Access Compliance Report

Public Rights-of-Way

(Curb Ramps)

Intersection ID: 10031811	Main Street: MILLENNIUM_AV	Cross Street: N/A	Location: W
ADA ID: 24850191AD5D	Ramp Type: Perp	Initial Pass/Fail: Fail	Overall Compliance: No
Severity Score: 12.5			
Codes/Mitigation Info/Possible Solution		Field Measurements/Component Compliance

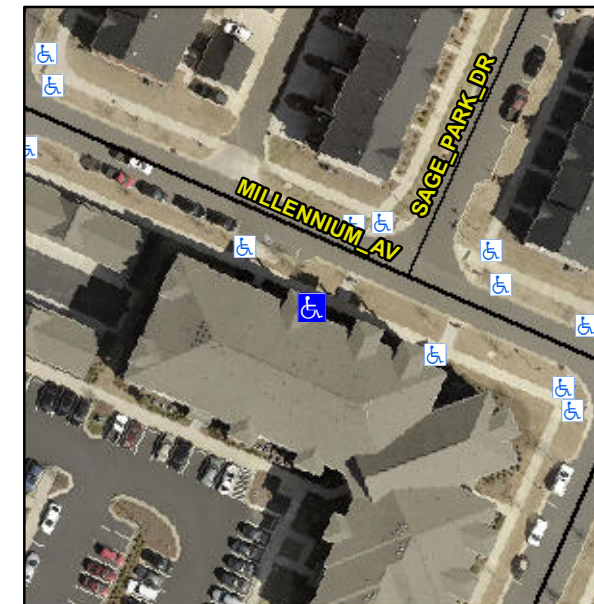
Not Found, R304.2.2

Compliance	Description	Data	Compliance	Description	Data
N/A	Ramp Length (in)	158.0	No	Ramp Slope (%)	8.7
Yes	Ramp Width (in)	68.0	Yes	Ramp XSlope (%)	1.0
N/A	Flare Type LT	N/A	N/A	Flare Type RT	N/A
N/A	Flare Slope LT (%)	N/A	N/A	Flare Slope RT (%)	N/A
N/A	Flare Traversable LT?	N/A	N/A	Flare Traversable RT?	N/A
N/A	Landing Length (in)	N/A	N/A	DWS Provided?	N/A
N/A	Landing Width (in)	N/A	N/A	DWS Contrast?	N/A
N/A	Landing Slope (%)	N/A	N/A	DWS Length (in)	N/A
N/A	Landing X Slope (%)	N/A	N/A	DWS Full Width?	N/A
N/A	Landing Curb? (Y/N)	N/A	N/A	DWS Offset (in)	N/A
N/A	Shared Landing?	N/A			
N/A	Gutter Ponding?	N/A	N/A	Gutter Slope (%)	N/A
N/A	Gutter Lip Ht (in)	N/A	N/A	Gutter X Slope (%)	N/A
N/A	Painted X Walk1?	No	N/A	Painted X Walk2?	N/A
	X Walk 1 Direction	To NE		X Walk 2 Direction	N/A
N/A	X Walk 1 Width (in)	N/A	N/A	X Walk 2 Width (in)	N/A
	X Walk 1 Slope (%)	0.8		X Walk 2 Slope (%)	N/A
	X Walk 1 X Slope (%)	2.0		X Walk 2 X Slope (%)	N/A

Remove & Replace Entire Ramp.
